Project Name: NE corner of Wellington & Bookcliff - Final Plat & Development Plan

FILE NO. 26-87 TITLE HEADING Final Plat & Plan Lots 1 & 2 DUE DATE 6-16-87
Little Bookcliff Sub.
 ACTIVITY - PETITIONER - LOCATION - PHASE - ACRES Final Plat & Development Plan, Replat
Lots 1 & 2 Little Bookcliff Subdivision, Northeast corner of Little Bookcliff Dr.
and Wellington Ave. contains 2.73 acres. Petitioner: SSM Investments,
Roger C. Shenkel

REVIEW SHEET SUMMARY RESPONSE

SITE PLAN SCALE 1" = 20'-0"

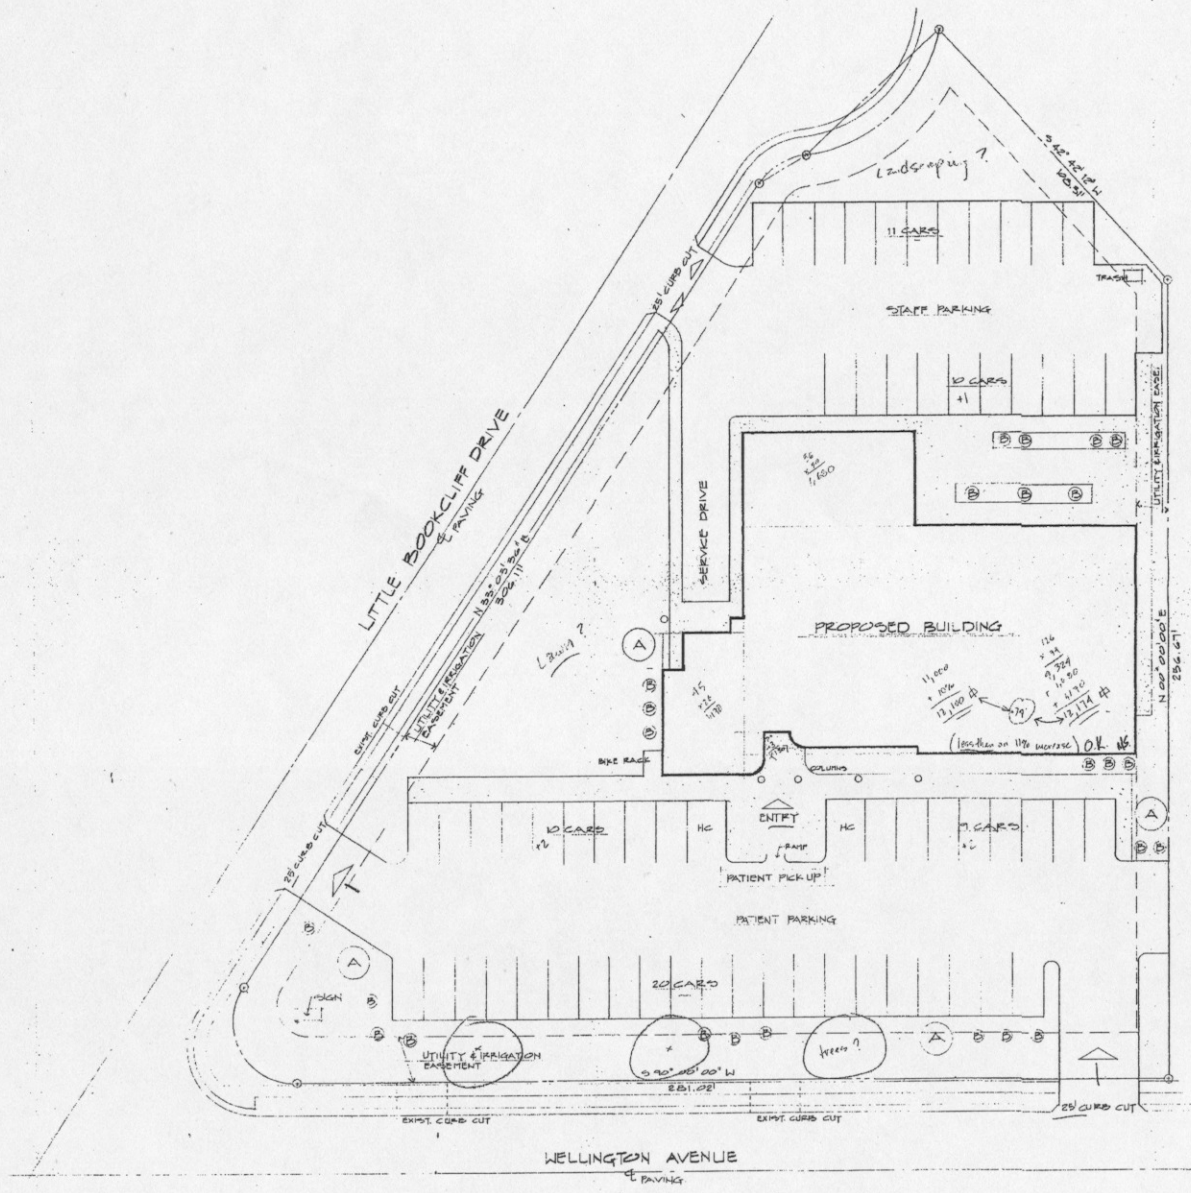
Changes O.K. provided all other
 site requirements be completed as approved
 by G.S. Planning Commission on 7-7-87
 Mike Schuchel
 8-11-87

Revised - Request for Minor Changes
